SERVICE LETTER NO. SL-1

EFFECTIVITY: Rockwell Commander 112 S/N 3 through 79

SUBJECT: Rudder Assembly

Figure 1.

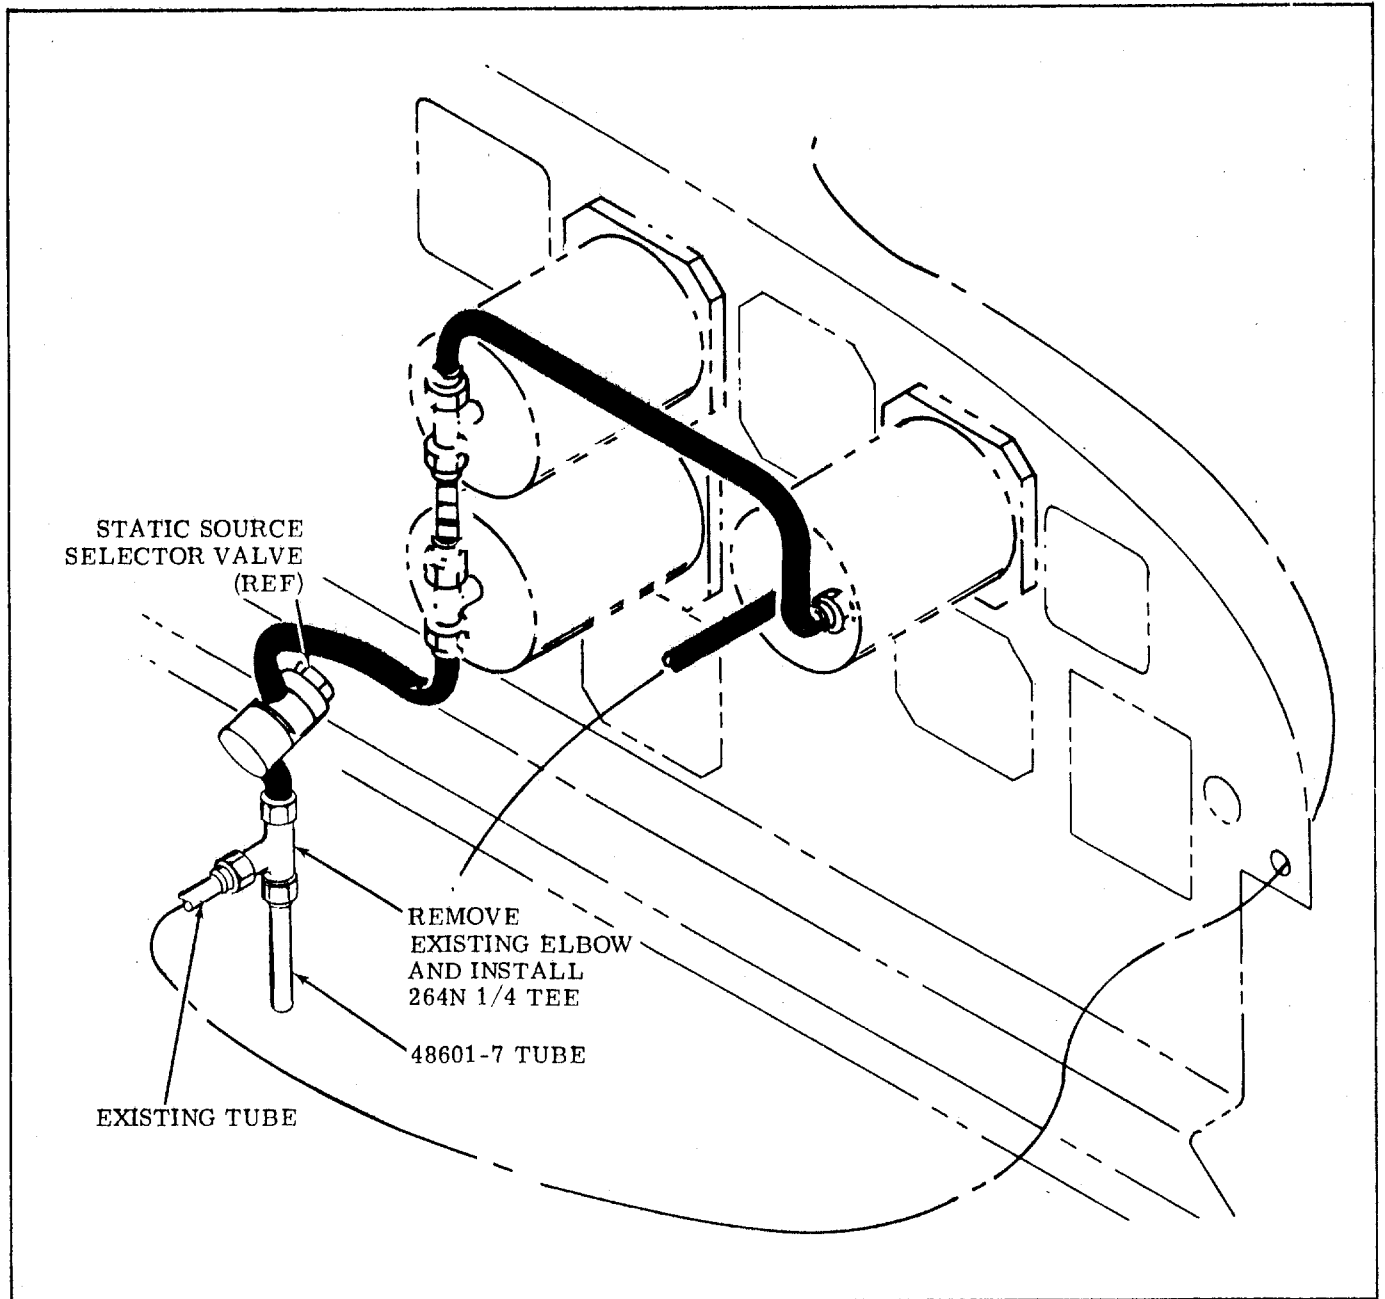
1. Remove interior console cover.
2. Remove knobs from control levers.
3. Remove quadrant plate to gain access to static source selector valve.
4. Remove and discard existing elbow from static source selector valve (see Figure 1.).
5. Install 264N 1/4 tee and 48601-7 tube on static source selector valve and reconnect existing tube (see Figure 1.).

Figure 1.

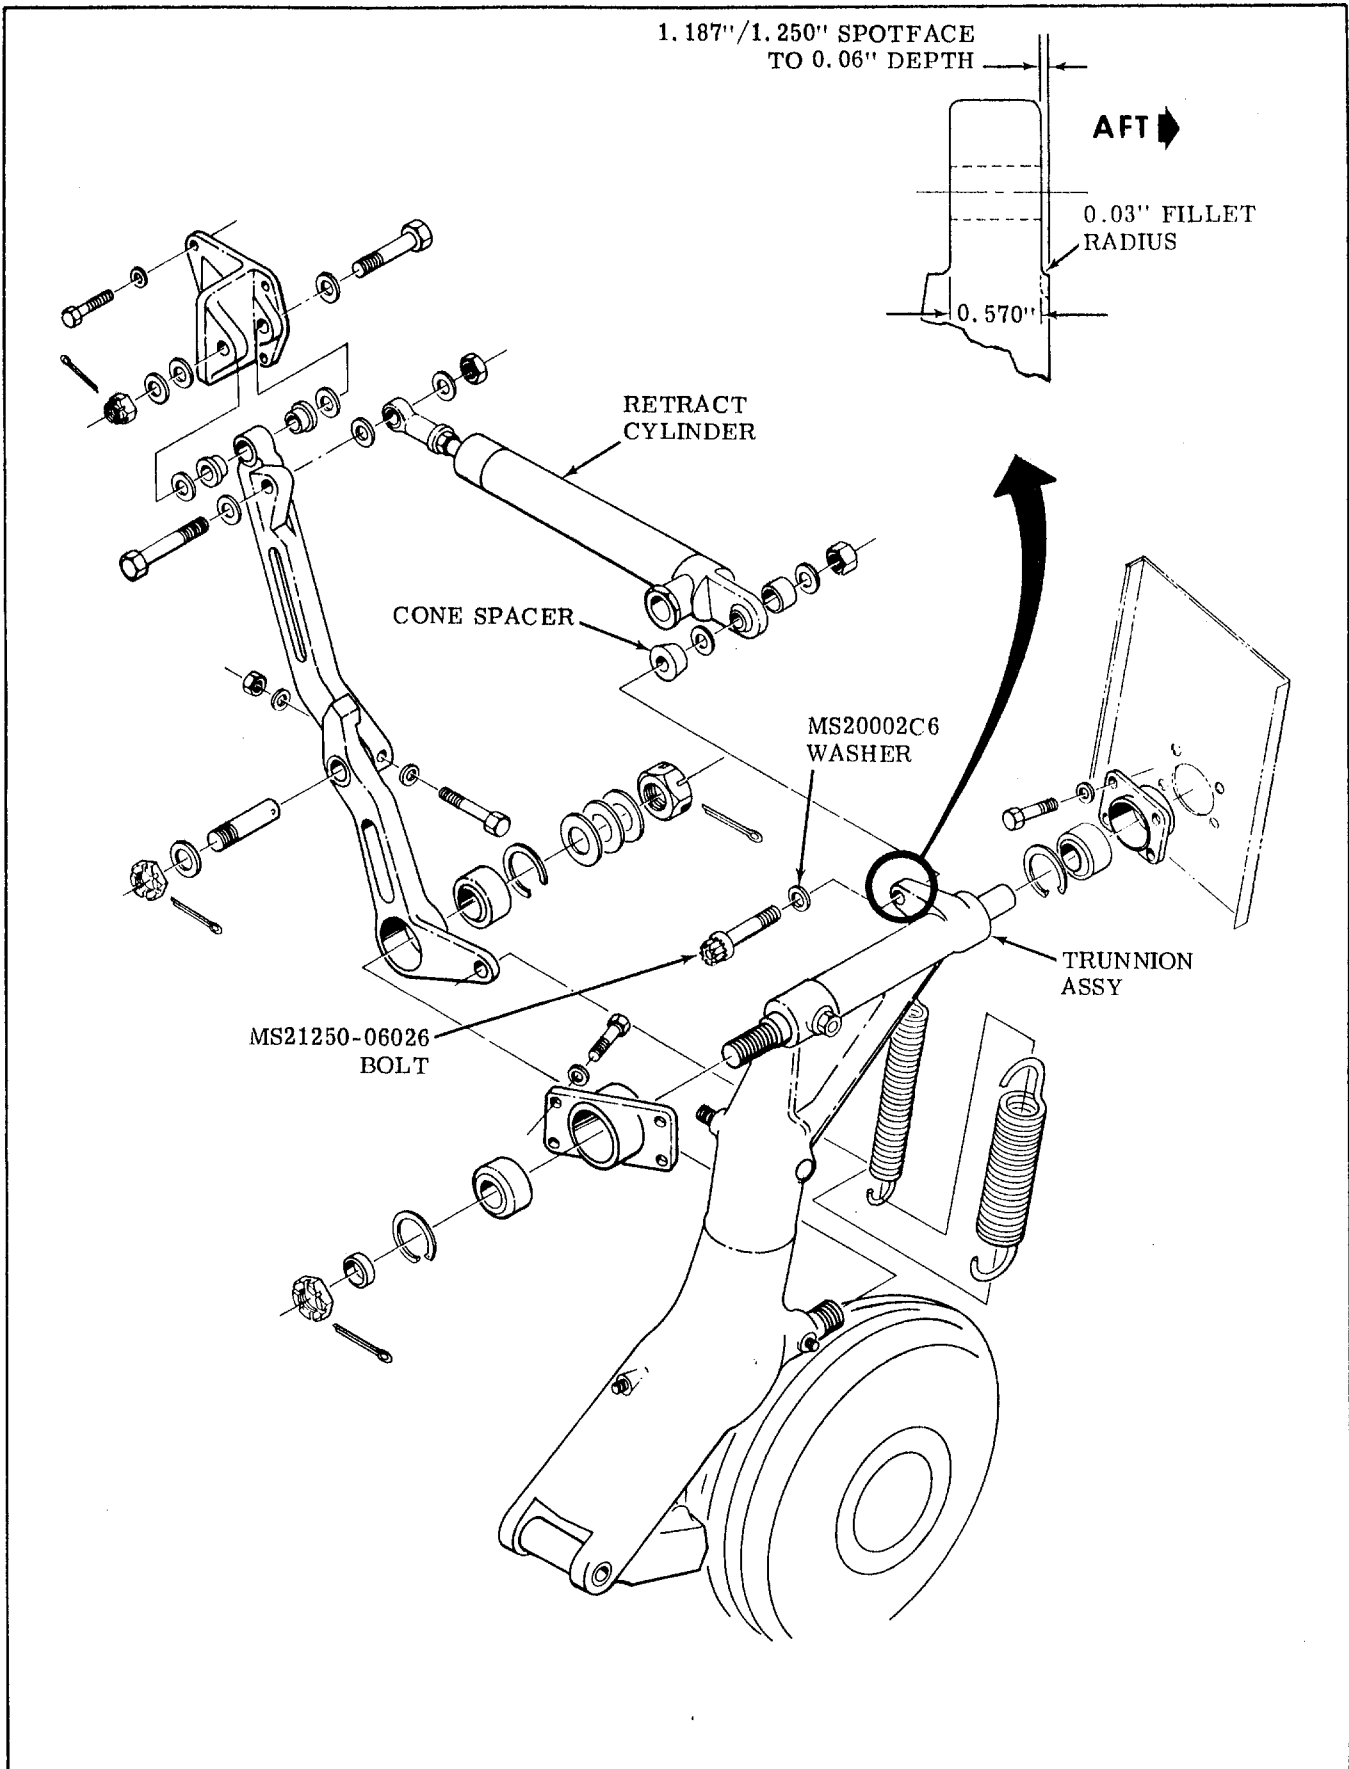
2. Remove and discard existing bolt and washer (under bolt head) that attaches outboard end of retract cylinder to lug on trunnion.
3. Spotface lug on left and right main landing gear trunnions to dimensions shown in Figure 1.

4. Attach retract cylinder to lug on trunnion using MS21250-06026 bolt and MS20002C6 washer (under bolt head) (see Figure 1.).
5. Check operation of landing gear system as outlined in the Model 112 Airplane Maintenance Manual, Section VI.
6. Remove jacks from airplane.
7. Proceed to RECORD COMPLIANCE.

Figure 1.

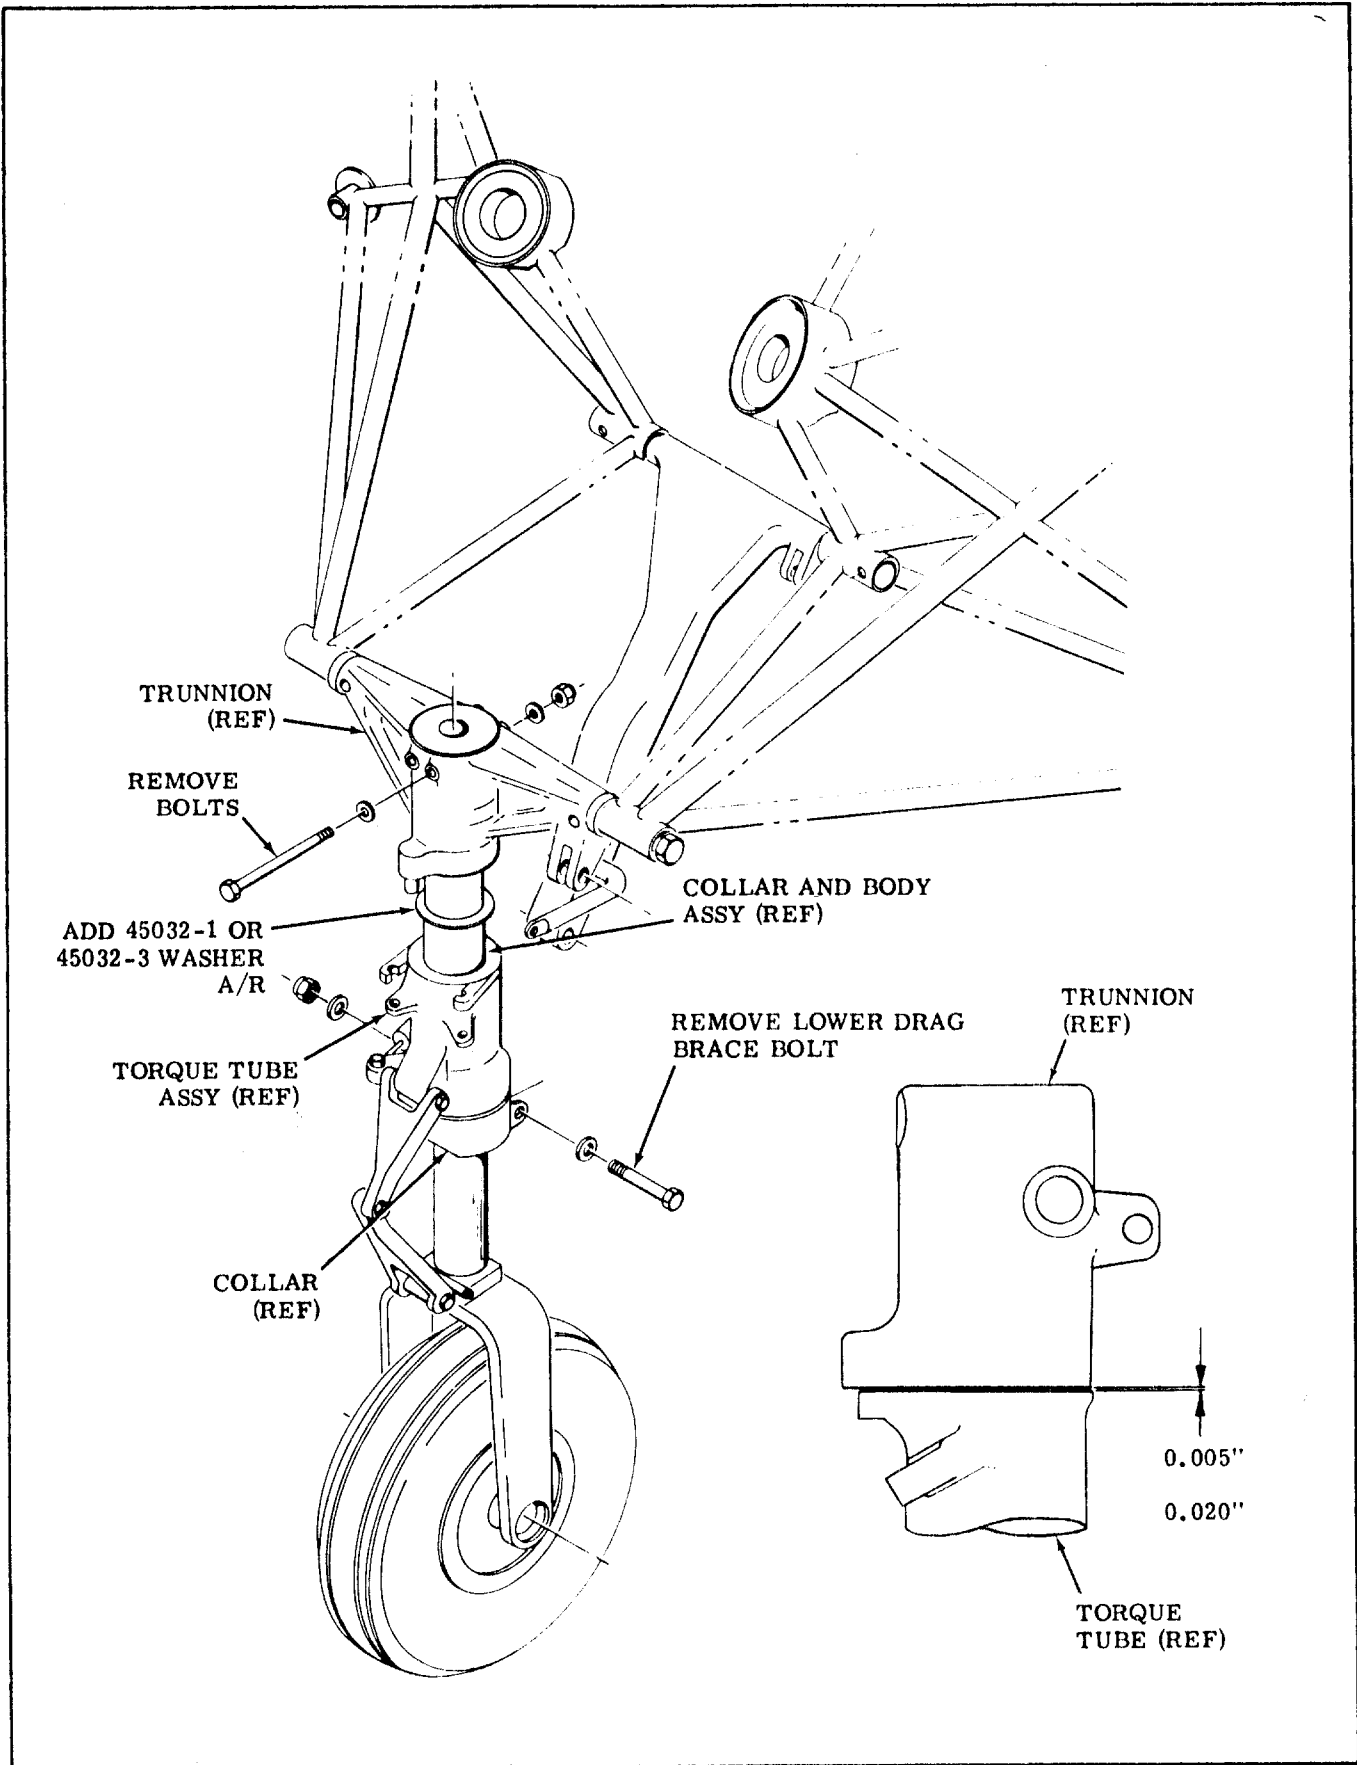
4. If gap between nose gear trunnion and torque tube is more than 0.020-inch proceed to step 5.
5. Disconnect nose gear steering cables and down springs.
6. Remove lower drag brace bolt at strut attach point.
7. Remove bolts attaching trunnion to body and collar assembly (see Figure 1.).
8. Remove nose gear strut assembly from trunnion assembly (see Figure 1.).

9. Install 45032-1 and/or 45032-3 washer as required to obtain clearance not less than 0.005-inch or more than 0.020-inch (see Figure 1.).
10. Reinstall strut assembly in trunnion assembly.
11. Reconnect drag brace to strut assembly.
12. Reconnect down springs and steering cables.
13. Functional test landing gear system to assure proper operation as outlined in the Model 112 Airplane Maintenance Manual, Section VI.
14. Remove airplane from jacks.

Figure 1.

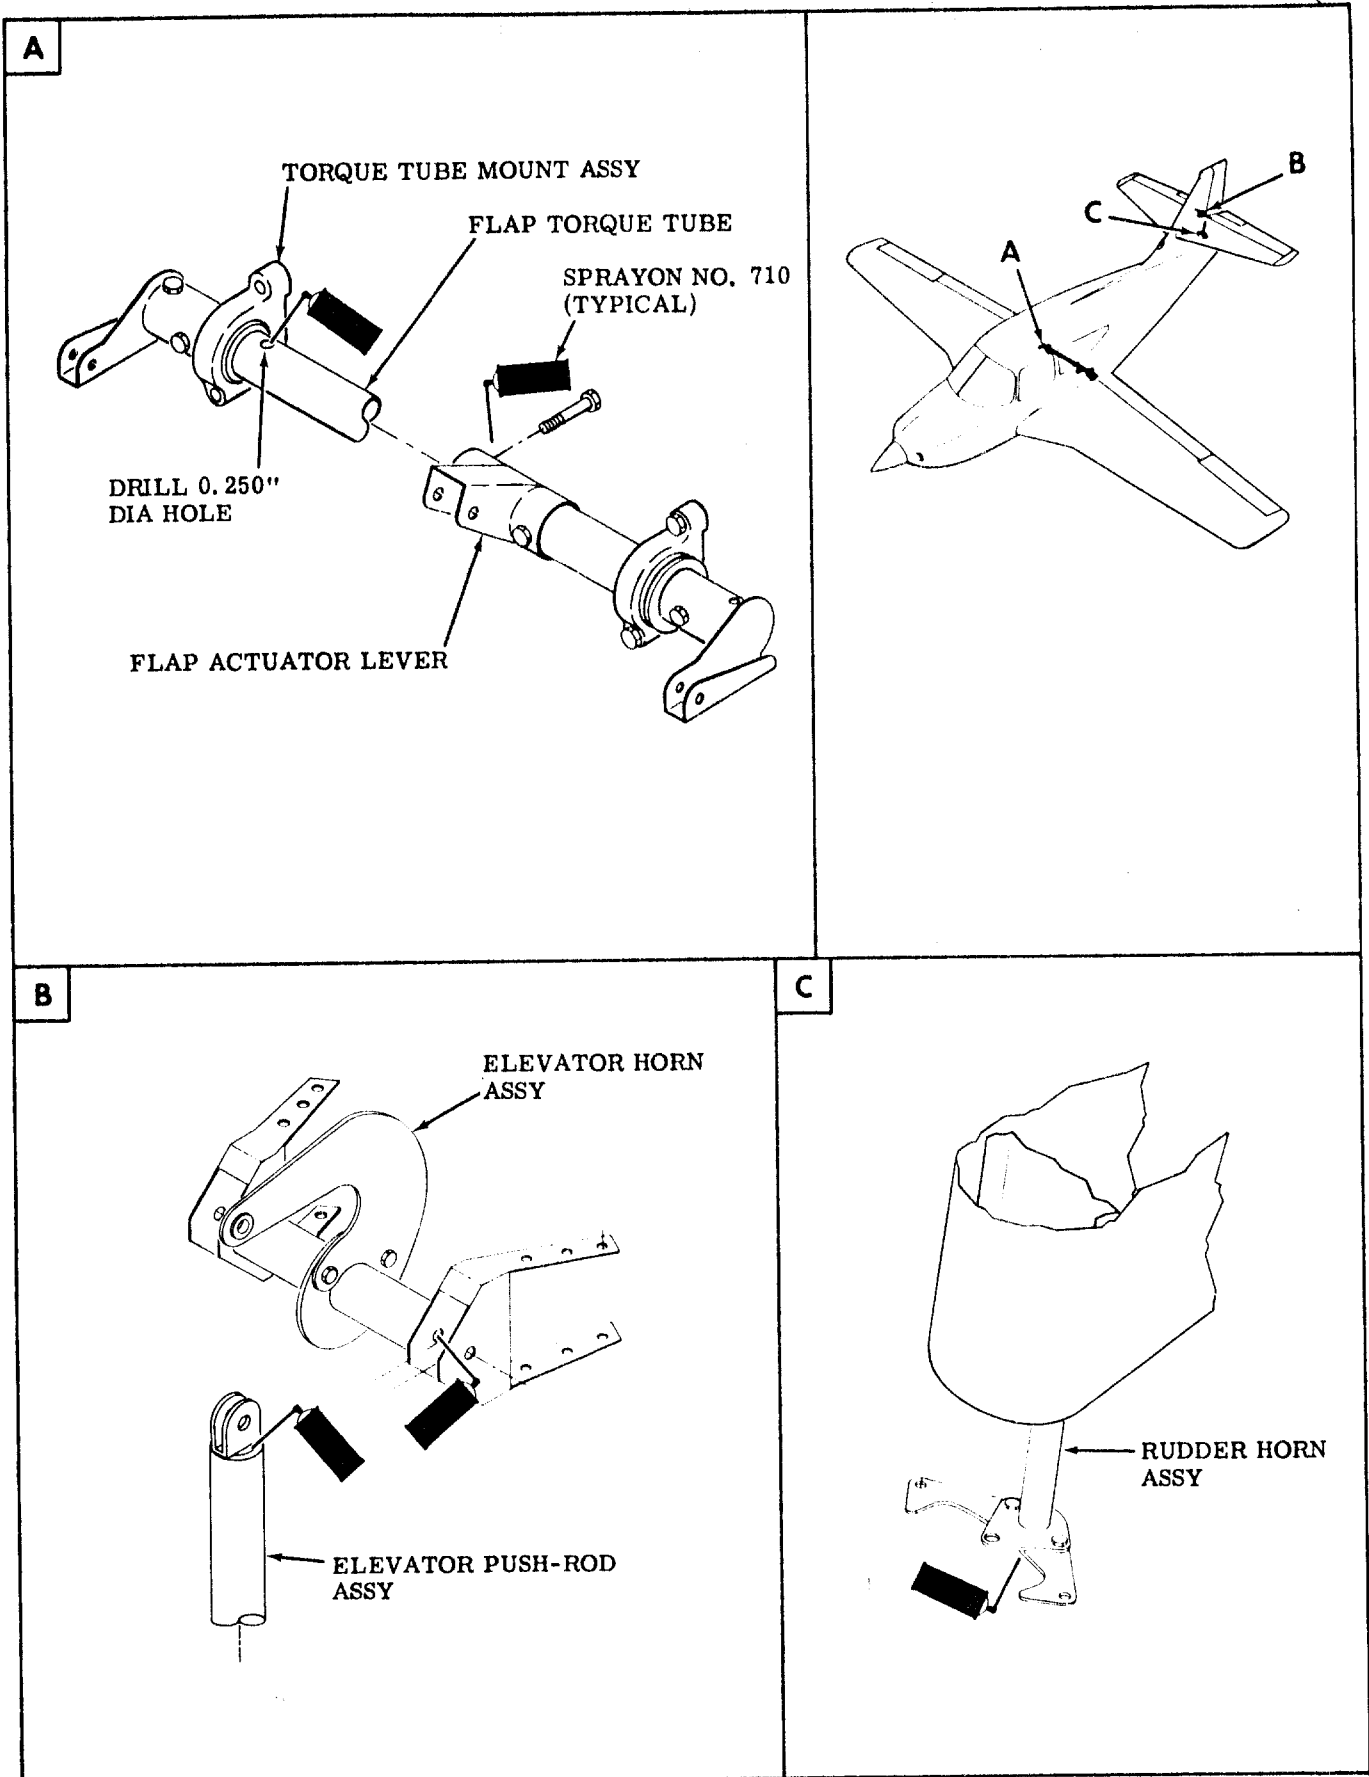
1. Remove screws attaching fiberglass stinger to aft fuselage, disconnect tail navigation light wiring and remove stinger from airplane.
2. Remove aft baggage curtain from baggage compartment.
3. Relieve tension on rudder cables and disconnect cables from rudder.
4. Remove bolts from rudder hinges and remove rudder from airplane.
5. Disconnect elevator actuator rod.
6. Remove six (6) screws and two (2) bolts at the inboard end of elevator.
7. Remove elevator hinge bolts and remove elevators from airplane.
8. Remove bolt attaching elevator push-rod assembly to elevator horn assembly.
9. Remove bolts attaching elevator horn assembly to horizontal stabilizer and remove elevator horn assembly from airplane.
10. Spray interior of elevator push-rod assembly, elevator horn assembly and rudder horn assembly with Sprayon No. 710 (see Figure 1.).

17. Drill a 0.250-inch diameter hole in the top of the flap torque tube. Hole to be located just inboard of right torque tube mount assembly (see Figure 1.).

18. Remove inboard bolt from flap actuator lever (see Figure 1.).
19. Spray interior of flap torque tube with Sprayon No. 710 (see Figure 1.).
20. Reinstall bolt, removed in step 18., in flap actuator lever.

Figure 1.

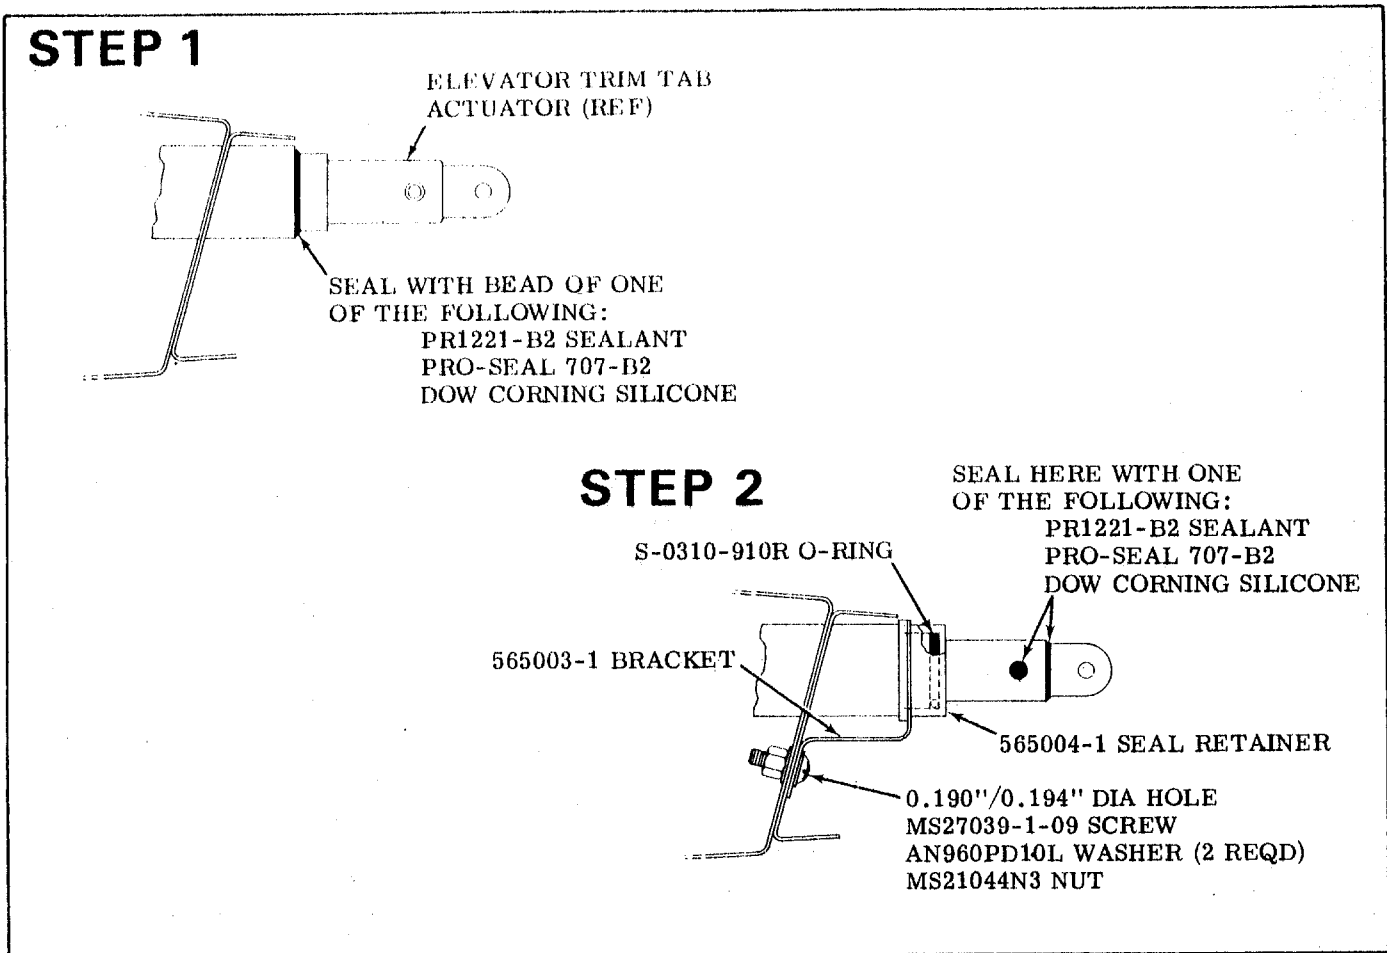
4. Add a bead of PR1221-B2 sealant, or Pro-Seal 707-B2, or Dow Corning Silicone around elevator trim tab actuator as shown in Figure 1.
5. Install S-0310-910R O-ring, 565004-1 seal retainer and 565003-1 bracket on elevator trim tab actuator, drill a 0.192 (\pm 0.002) inch diameter hole through bracket and elevator spar and install MS27039-1-09 screw, AN960PD10L washer (2 places) and MS21044N3 nut (see Figure 1.).
6. Cover clevis joint and both ends of roll pin with either PR1221-B2 sealant, Pro-Seal 707-B2 or Dow Corning Silicone (see Figure 1.).
